**82 – 106 ANZAC PARADE, KENSINGTON**  
**2013SYE051**

Kensington Apartments, 84-104 Anzac Parade, Kensington  
Landscape Concept Design Report, Development Application  
04 December 2013 E - For Approval

1. **Proposed Mixed Use Development**  
**84-108 Anzac Parade, Kensington (DA/ 320/2013)**

**DA/320/2013 – Demolition of the existing buildings; excavation works and construction of a part 6, part 7 mixed use development comprising ground level retail space, 109 residential units and 3 basement levels of 277 car spaces and associated landscaping works at 84-108 Anzac Parade**

Site Image - colour rendered landscape concept plan

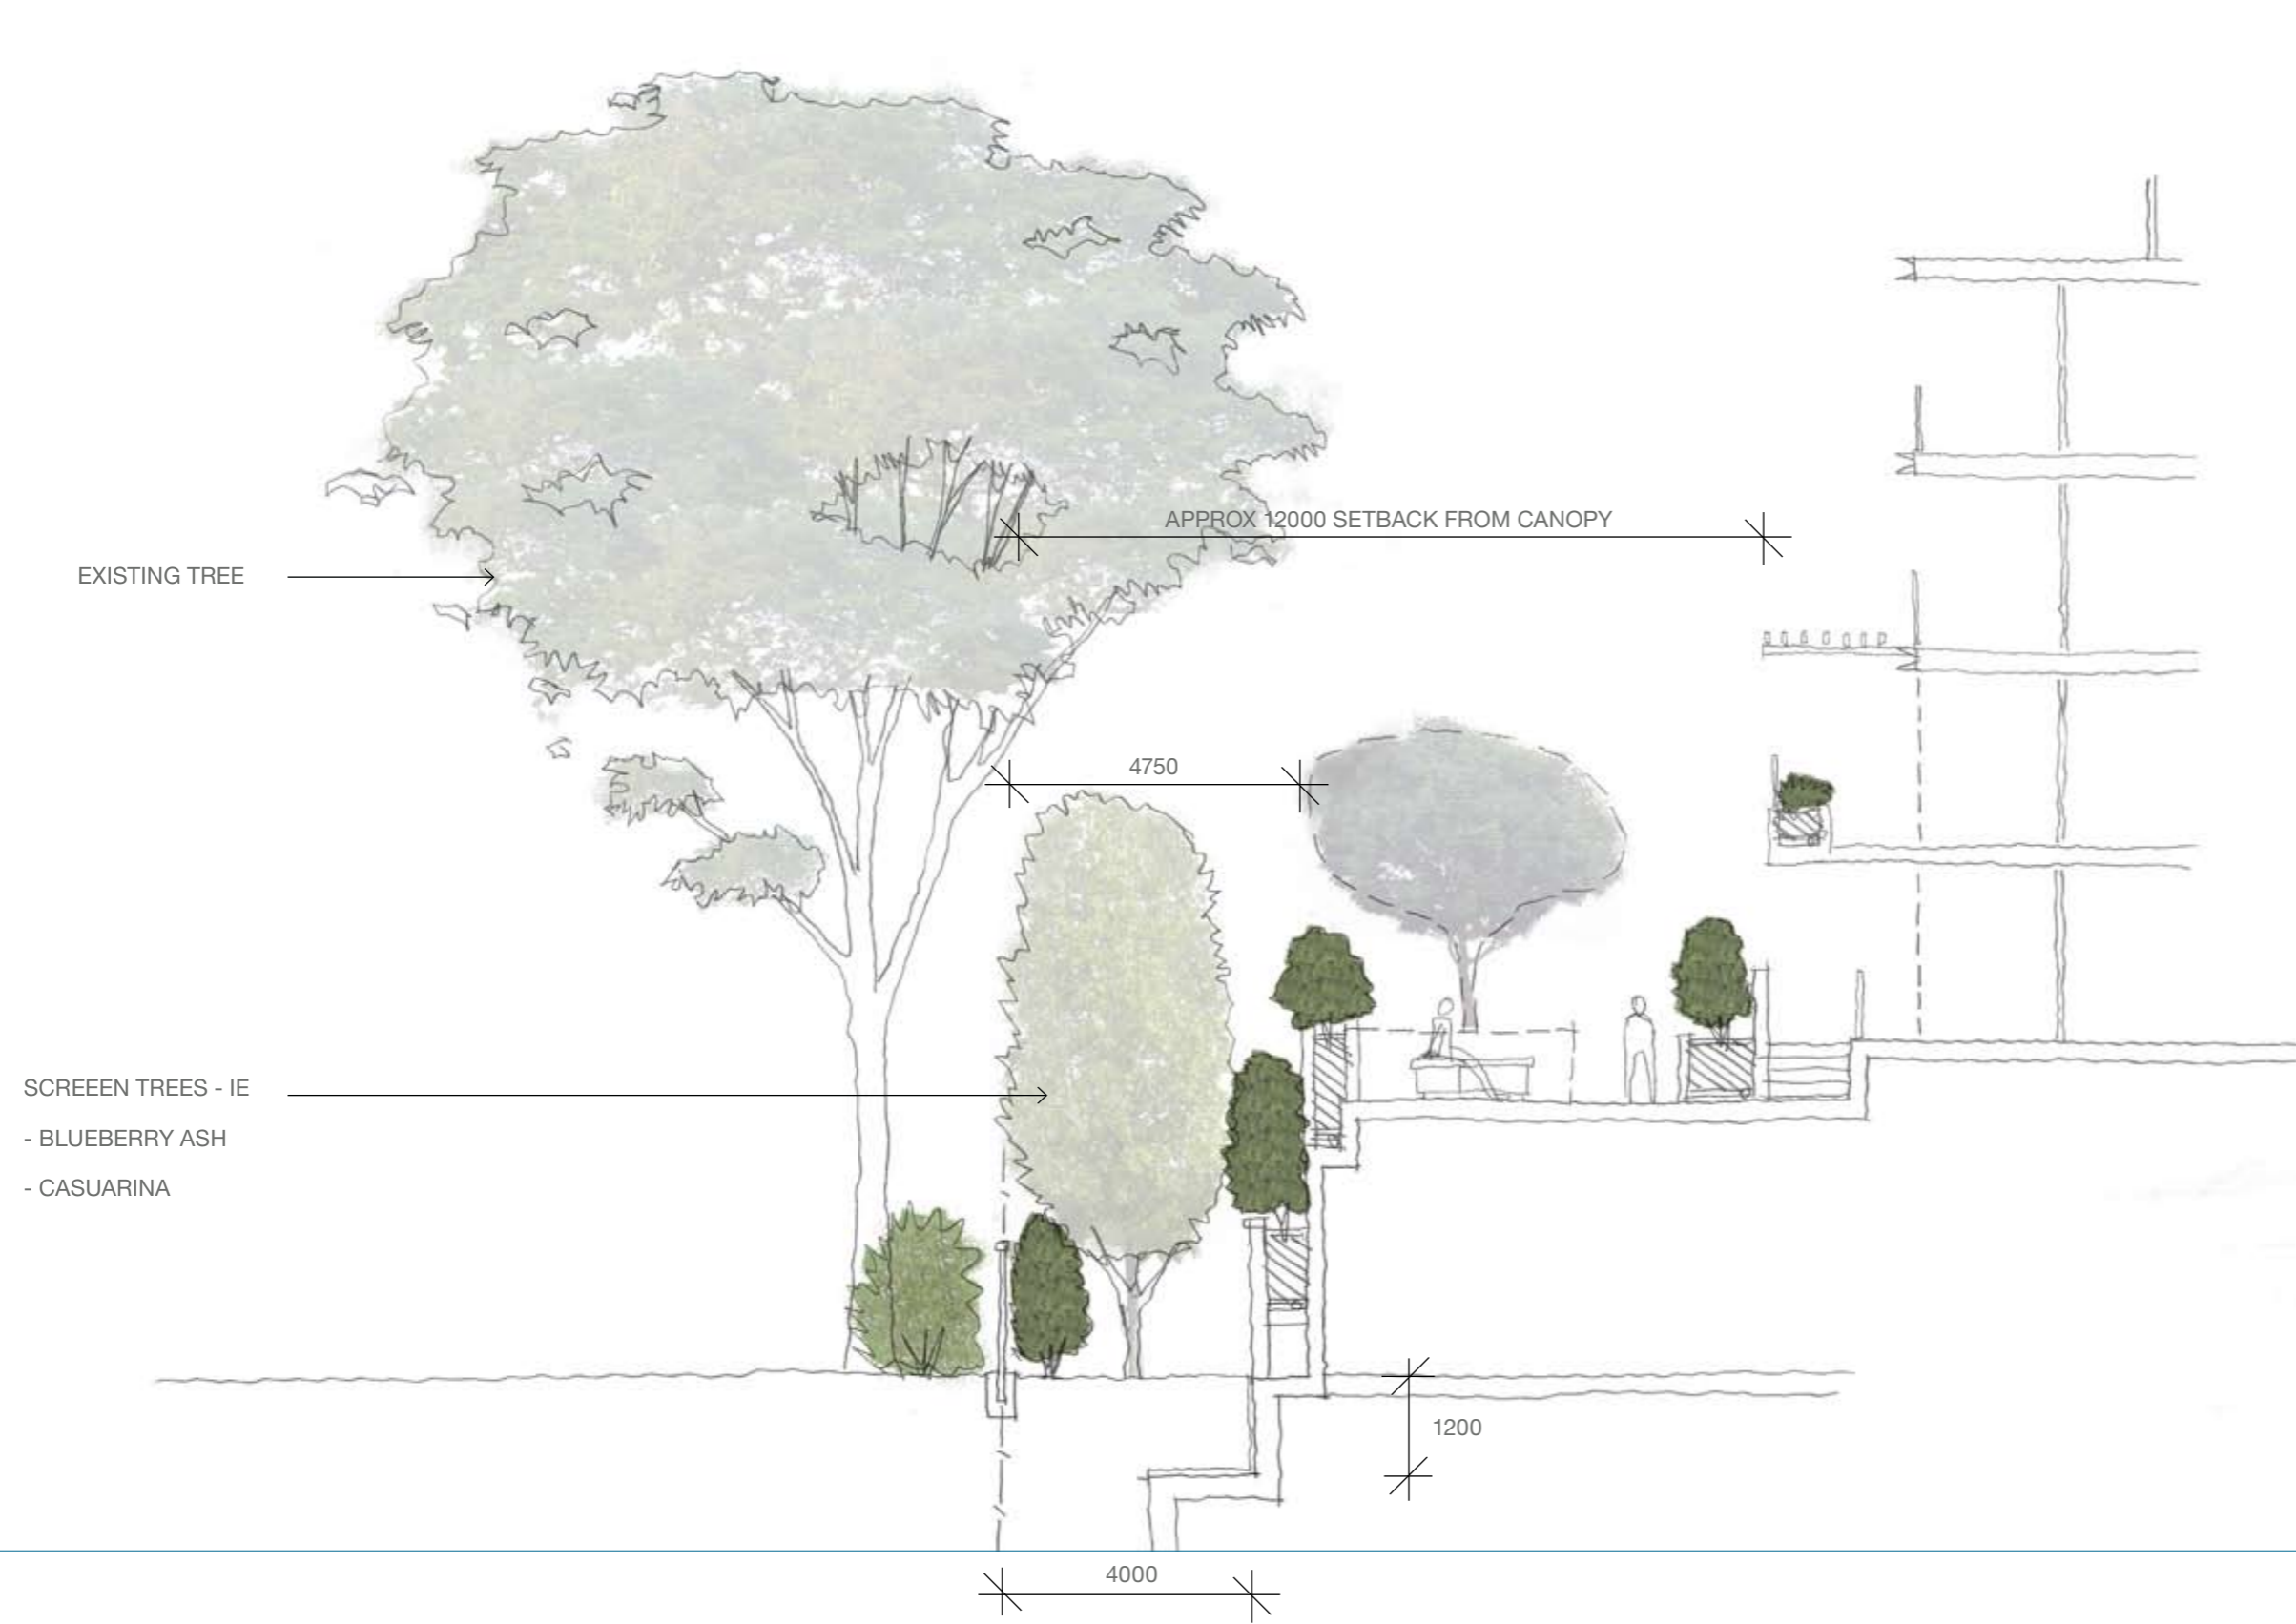
## A.2. AMENDED EASTERN BOUNDARY LANDSCAPE

The podium landscape is complimented by a planter set into the eastern frontage with screening shrub species, which will combine with the significant podium edge and podium landscape to create a green edge to the neighbouring residential properties. Existing trees along the boundary, and setback of residential buildings is believed to create a suitable relationship between the proposed building and existing residential buildings. This relationship replicates the recent development of the adjoining property to the north of the subject site.

The podium landscape includes a range of different amenity areas and facilities, including swimming pool, playground, outdoor gym, seating areas, shading pergolas, and series of water features. Significant massed planting to the eastern boundary is in raised planter with soil depth of 600mm on the podium edge for massing shrubs, and sloping up to 1000mm depth for taller planting. Raised planters occur between different amenity areas as shown on the plan, with planters also flanking the water features.

Eastern Boundary Landscape Section AA

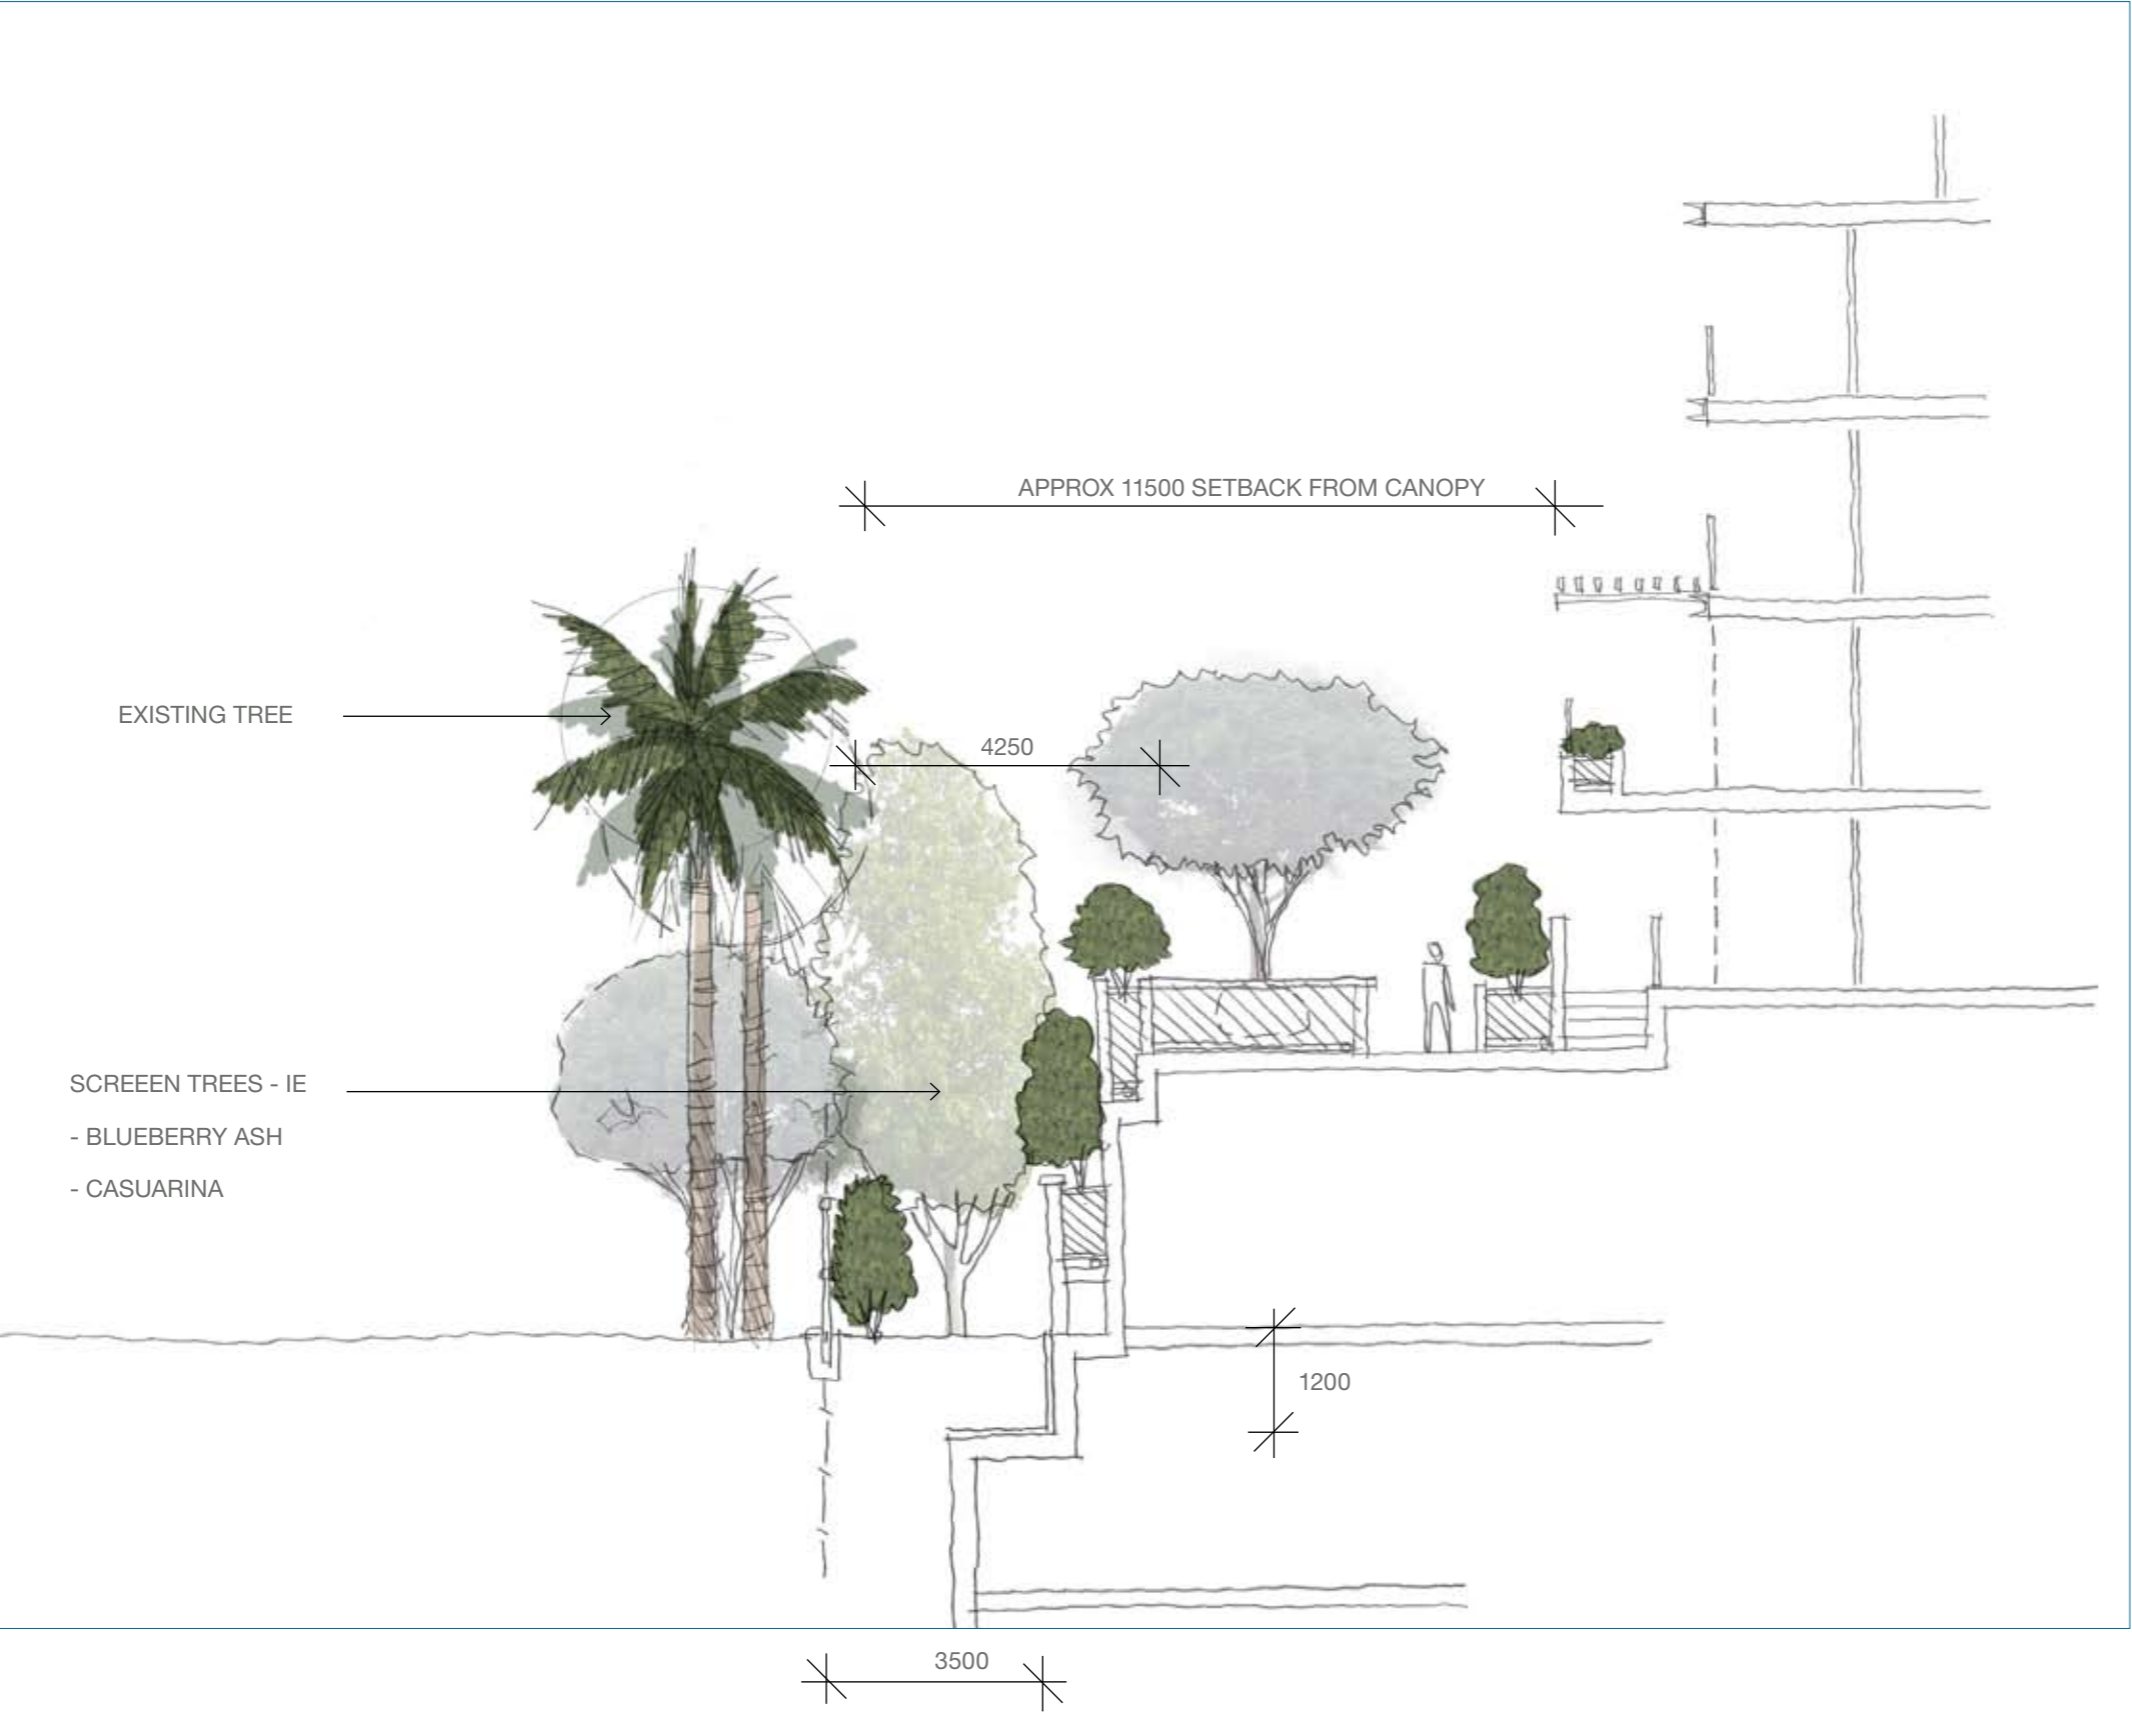
The Existing Eucalyptus sp. tree on the adjoining property is complimented by low, medium and high level planting to complete the landscape screen for views from the adjoining area.

**(84-104 Anzac Parade in Kensington, Concepts of Basement Construction. Reference: 238419  
Prepared for: Luxcon Revision: 0 - 27 September 2013)**

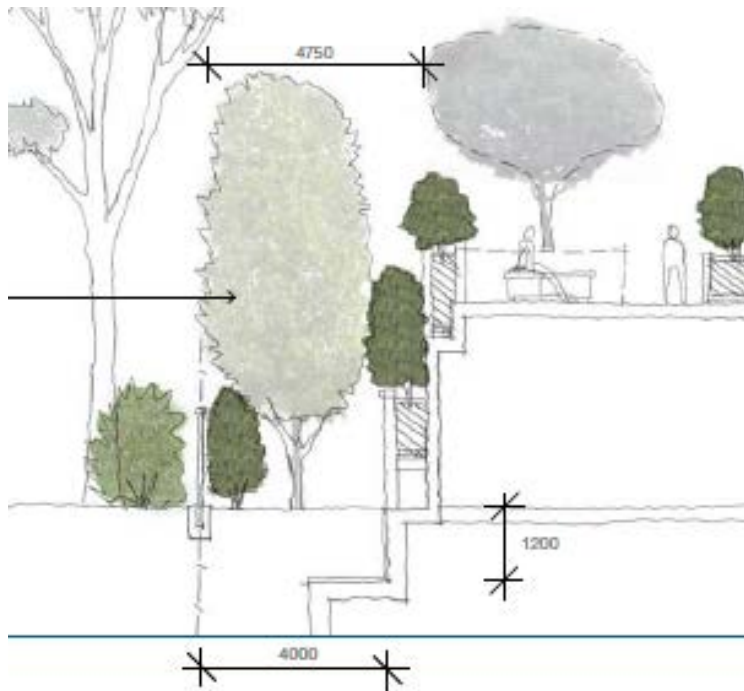
*The proposed basement level car parks will be below the water table in Kensington and will necessitate the use of full time pumps to extract the water, which is not an energy efficient practice. As noted in the DCP, the Department of Land and Water Conservation will not endorse continuous extraction of groundwater.*

This was addressed in the report submitted along with the DA:

Aurecon have not recommended the use of pumps as a method of extracting water from the site:

Proposed section through Eastern Boundary

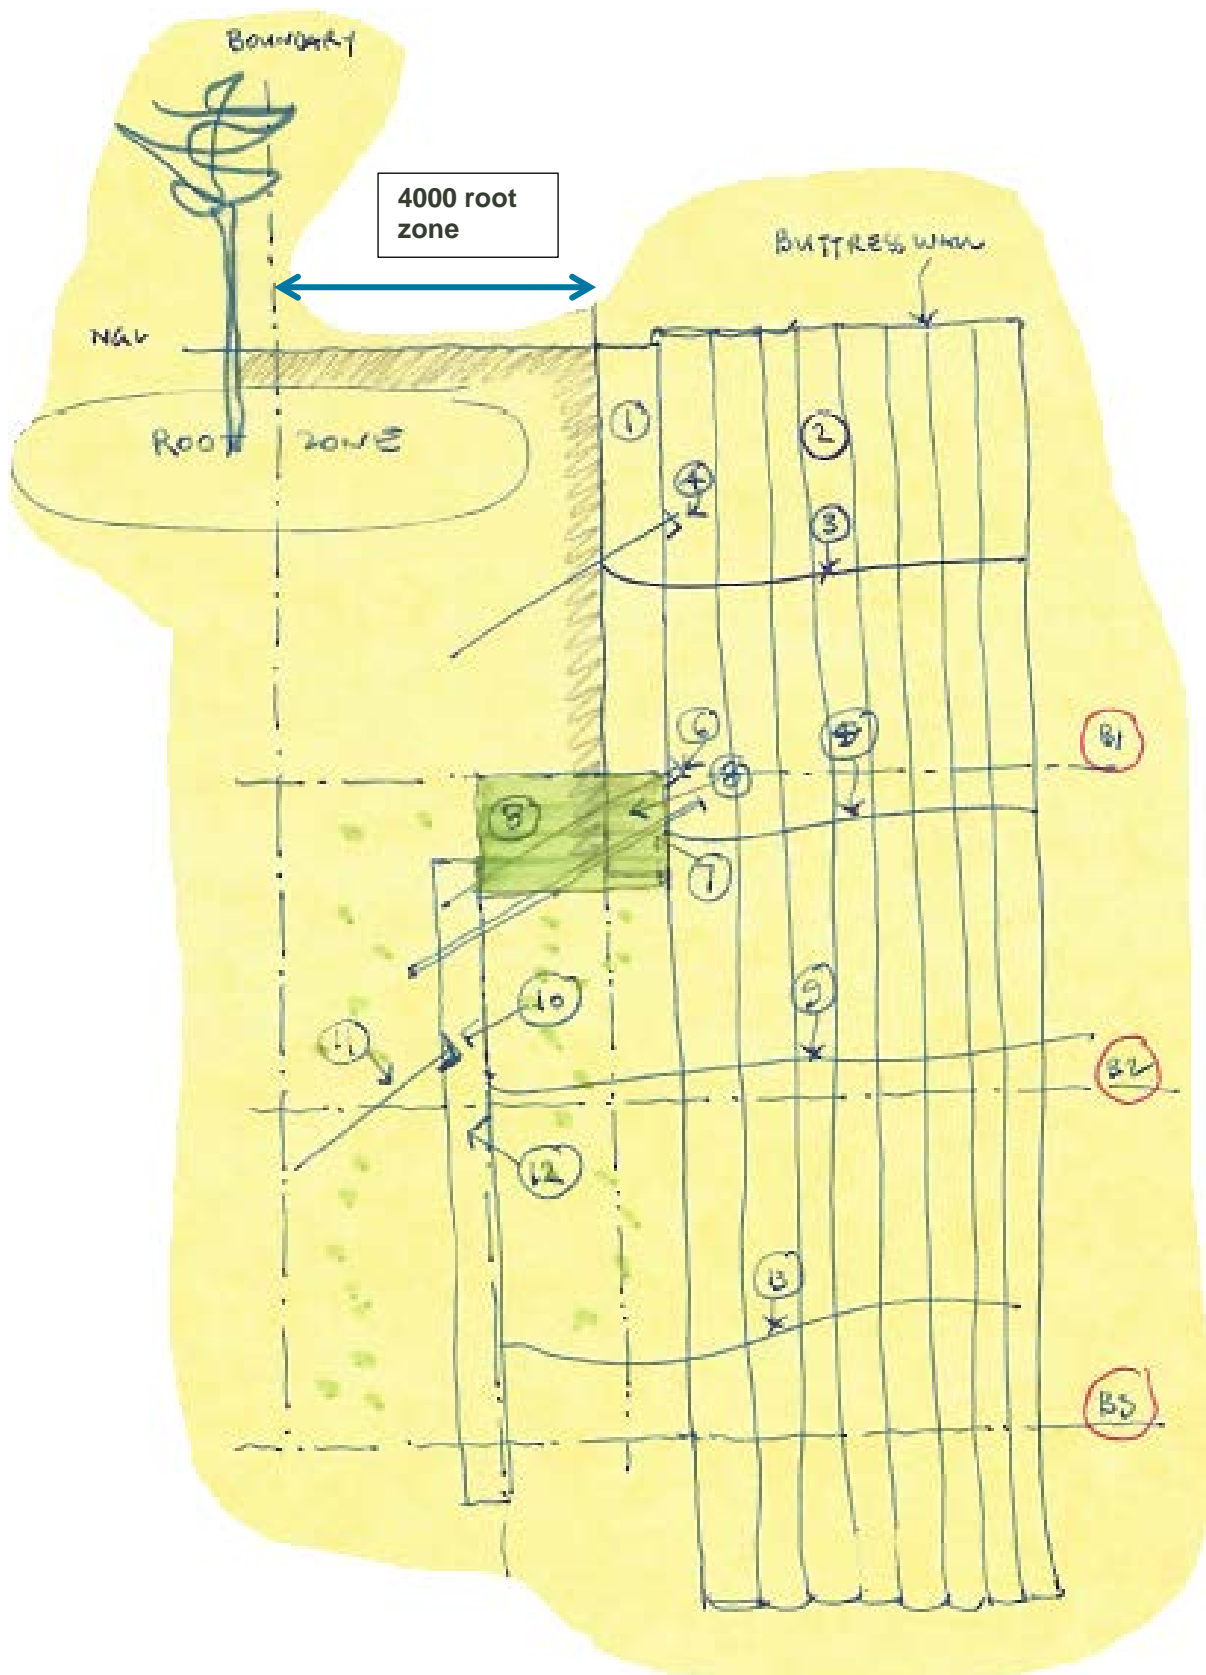
*Despite Council raising the presence of these trees as a major issue and site constraint for any development, alternative schemes and re-designs to lessen the impacts have not been provided or suggested, neither has the extent of pruning required to avoid damage by a piling rig in such close proximity, as well as the amount required to provide a clearance off the building both during construction as well as upon completion.*

*Council's primary focus is to ensure that these neighbouring trees are not compromised in anyway; and unfortunately, on the information provided to date, there is no way that Council can issue consent as the applicant has not been able to prove, with any degree of certainty, that these neighbouring trees will not be seriously and adversely affected by the works.*

Aurecon have outlined below our proposed alternative excavation methodology

We have based the following shoring alternative on the Landscape section developed by Site Image.

Proposed Alternative shoring Scheme. Refer Key below

1. Install secant pile walls to the underside of the B1
2. Install Piles to form Buttress walls
3. Excavate first lift approximately 2 metres in depth
4. Install first row of temporary anchors into the secant pile wall

5. Excavate the 2nd level approximately 1.5 metres in depth
6. Install the second row of anchors into the secant pile wall
7. From the base of the second excavation depth of the B1 slab location , inject a grout/soil mix for the entire width of zone A to the depth of the BEL

8. Excavate locally in segments to create a reinforced header beam to provide vertical support to the piles and the area immediately behind the piles
9. Excavate 2 metre down to expose the soil grout mix

10. Excavate the grouted area to a line 300 mm beyond the proposed excavation line
11. Install temporary anchors
12. Construct a 400 mm thick reinforced shotcrete wall and connect the shotcrete wall by a return to join the buttress wall created from the secant piles

13. Repeat the steps 9-12 until the base of the excavation has been reached.
